Service Bulletin

ExpressCard 2000 XY Transport Cable Clamp Retrofit Document Number D998200204-11

Rev Number	Date	Notes
10	Jun 28, 2017	Initial Release
11	Jan 04, 2018	Correct missing step to reconnect cables to J3 and J4

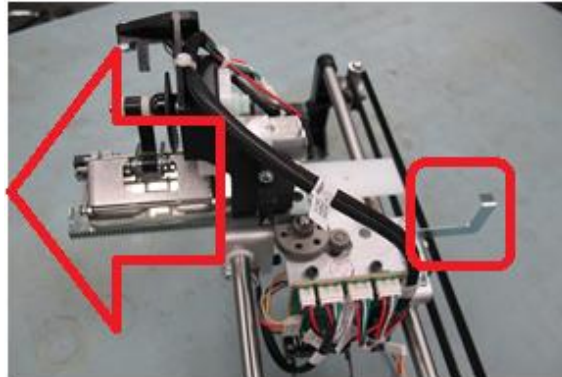
23) Reconnect the 2-pin connector disconnected earlier to the **J3** header.

24) Reconnect the 4-pin connector disconnected earlier to the **J4** header.
